Application for Public Hearing VARIANCE

Address/Location of Property in Question: 1201 N. Euclid Ave

Re: Project Summary 1201 N. Euclid Ave. Parking Variance

Plan Review Corrections

BOUNDARY SURVEY

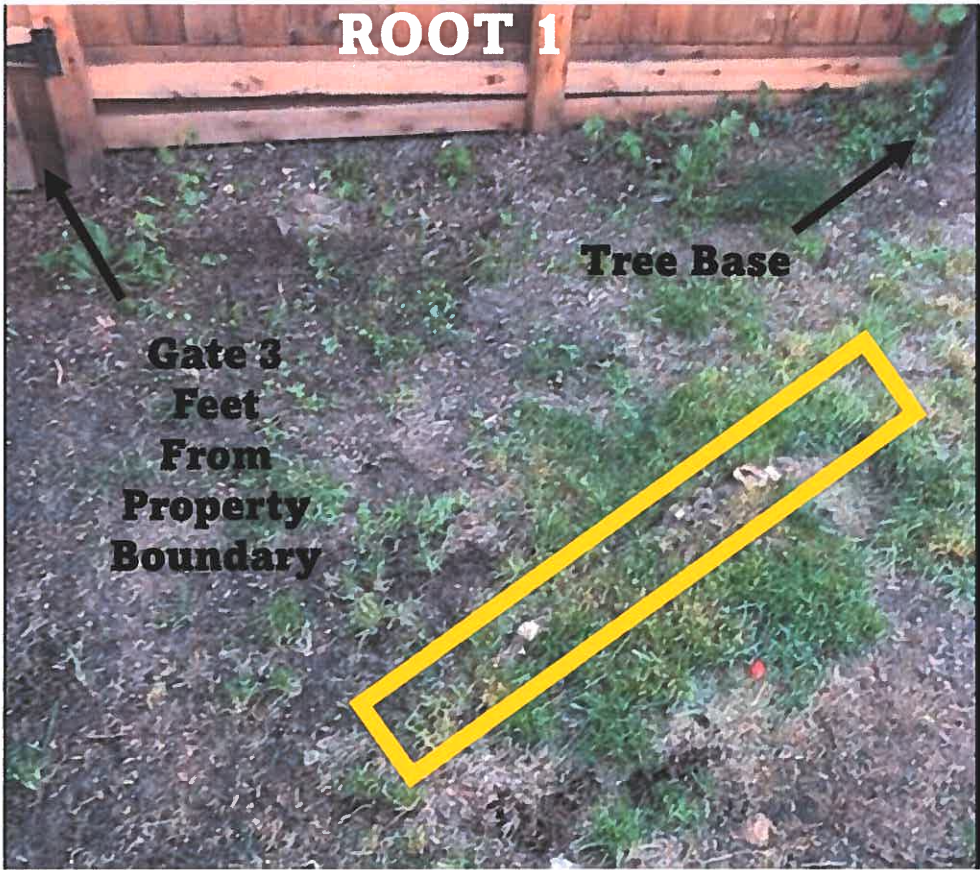
1. Parking is not allowed between the south lot line and 13.5 feet to the north. Parking is not allowed closer to the corner side lot line than the front building façade line.
2. Parking not allowed in this area. Further, parking on gravel is prohibited.
